City of **HOBART**

APPLICATION UNDER HOBART INTERIM PLANNING SCHEME 2015

Type of Report:	Committee
Committee:	1 February 2023
Expiry Date:	3 February 2023
Application No:	PLN-22-790
Address:	83 MELVILLE STREET , HOBART 80 BRISBANE STREET , HOBART
Applicant:	(University of Tasmania) C/- All Urban Planning Pty Ltd 19 Mawhera Avenue
Proposal:	Alterations to Previously Approved Development for Pedestrian Bridge
Representations:	Thirteen
Performance criteria:	Central Business Zone Development Standards, Potentially Contaminated Land Code, Inundation Prone Areas Code

1.1 Planning approval is sought for Alterations to Previously Approved Development for Pedestrian Bridge, at 83 Melville Street and 80 Brisbane Street, Hobart.

Figure 3: Ground and upper floor plan of laneway and proposed pedestrian bridge.

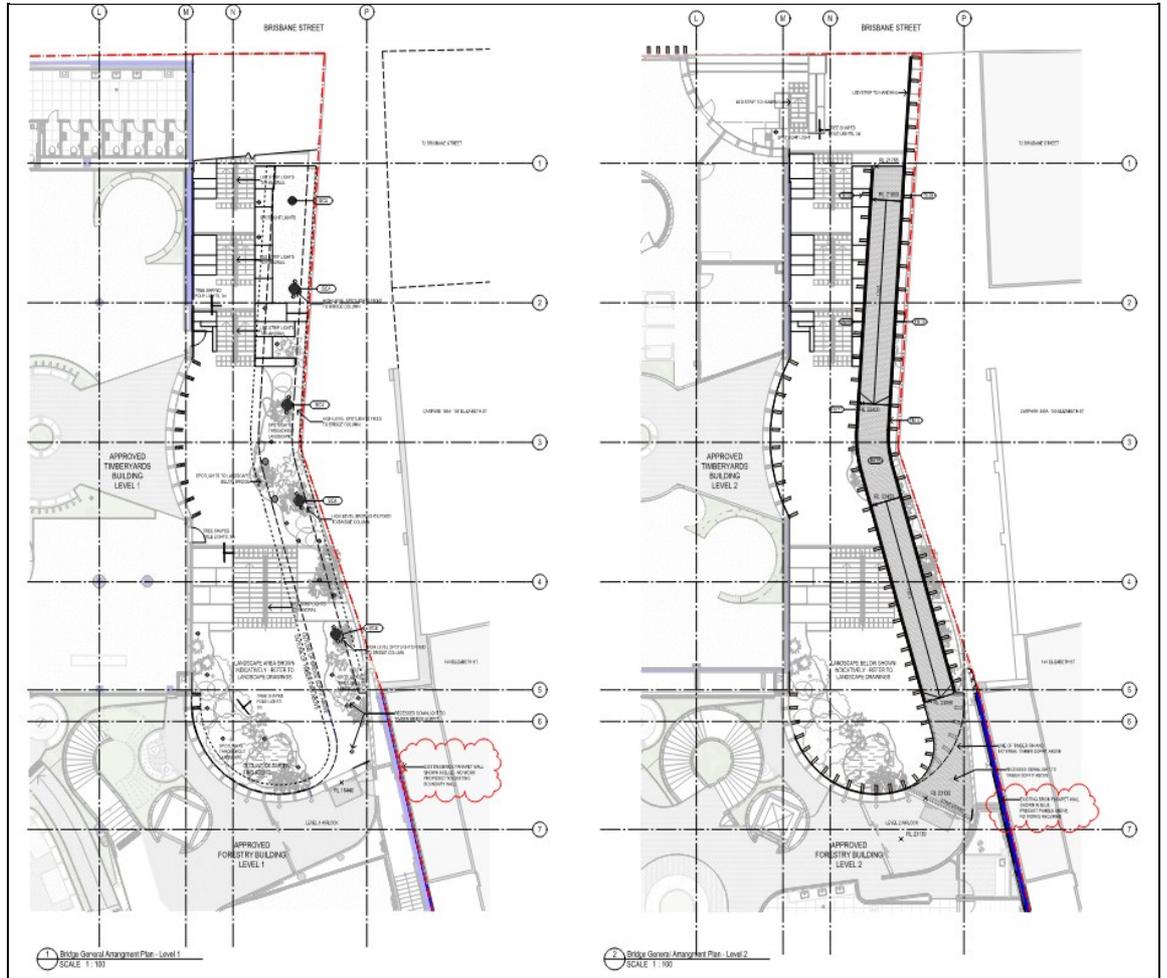
- Concealed spaces will be created underneath the proposed pedestrian bridge
- The drawings show that sight-lines from the boundary with Brisbane St to the pedestrian entrances of the building will be blocked by the angled boundary wall, the columns supporting the bridge above, the proposed landscaping and the vertical timber fins at the sides of the bridge.

- Proposed landscaping will be inconsistent with conditions of 2022 approval and will create sight line issues

In terms of the visibility of the ground floor (noted on the plans as Level 1) entrance, it is considered that the proposal will still allow it to be seen from Brisbane Street, in the same way as approved under PLN-21-869. The advertised plans demonstrate that the bridge will provide a clearance of between 3.4m and 5.1m which would be sufficient to provide a line of sight between the footpath and both the airlock entrance and internal doorway into the building. Representation repeated concerns that the timber battens from the proposed pedestrian bridge would obscure visibility. Whilst they may increase the visual and bulk of the bridge structure, the battens will not extend lower than the bridge itself, minimising any intrusion into the line of sight between the building entrance and the footpath. Additional photo renders were supplied by the applicant following the conclusion of advertising which are supplied below in Figure 6 and Figure 7, and at Attachment D to this report. These renders demonstrate the extent of visibility between the entrance and public footpath.

With respect to subclause (f) and (g), public access remains unchanged on the site, as above there will remain clear sight lines between entrance and public spaces which will provide for high visibility for users of the space. As addressed above, the inclusion of the pedestrian bridge does not compromise or impede the sight lines from the entrance to adjacent public spaces. The bridge itself will have chain mesh balustrading which will also allow for visibility of the laneway space, in addition to the visibility from buildings on the site.

Representations have also repeated concerns over the additional creation of concealed spaces and the management of the space. As evident in the advertised plans, the entire space will be lit by floodlights and downlights to minimise concealment space. Landscaping will also be provided alongside and underneath the bridge to either limit access to the area between the bridge and laneway floor or make the space open and useable. Noting the previous conditions for landscaping under the 2021 approval, and the advertised documentation for the current application, there is limited opportunity for the creation of concealed spaces or entrapment. A condition is proposed for the current application for any variation in the landscaping approved by the previous permit must be approved by the Director City Life and will take into account the potential for concealed spaces. CCTV coverage will be available across the entire laneway and as already noted in the advertised documents, a 24 hour manned security office will be located on-site overseeing those cameras and conducting patrols. The creation of the laneway allows for the extension of the public realm into an otherwise space of limited engagement or use, appropriate efforts have been taken by the applicant to ensure that the design of the space and buildings provides for the safety of the public.

Figure 4: Elevations of proposed pedestrian bridge.

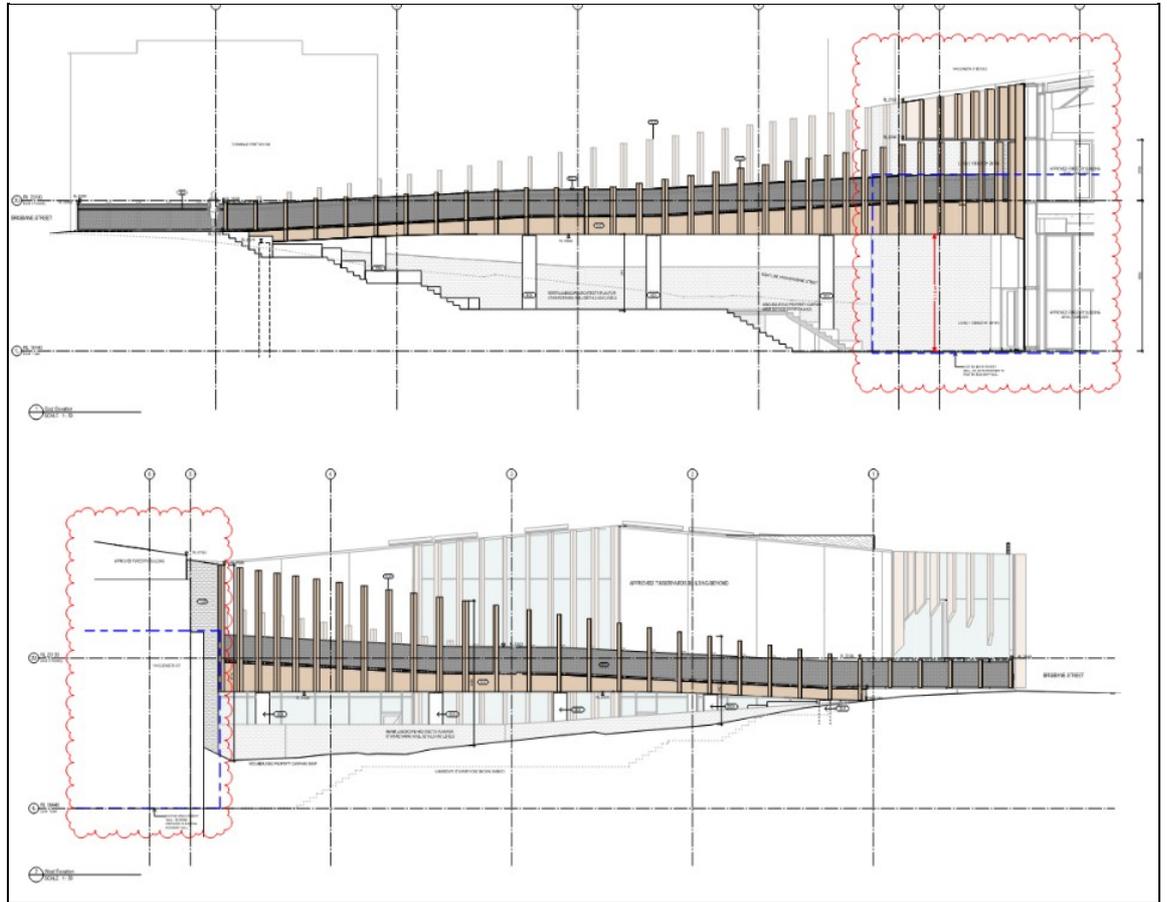
- The proposed pedestrian bridge does not comply with the requirements for Passive Surveillance (Clause 22.4.4 of the Hobart Interim Planning Scheme 2015).

the building around 16m closer to Brisbane Street than the currently existing situation for the building (refer Figure 4 above). The location of the new entrance was assessed as being compliant with the performance criterion as the it would remain clearly visible from nearby buildings and public spaces. Further conditions were imposed to have a landscaping plan endorsed that would ensure all vegetation would be at a low level and that lighting would be sufficient to minimise and dark area at night. This plan was supplied and endorsed by officers following the approval of the application.

As noted above, the intent of the new pedestrian bridge is to enable level access into the building off Brisbane Street, which currently does not exist. In doing so, it creates a new pedestrian entrance into the building, which will be visible from Brisbane Street. That is, the new bridge doesn't impede visibility of the new entrance.
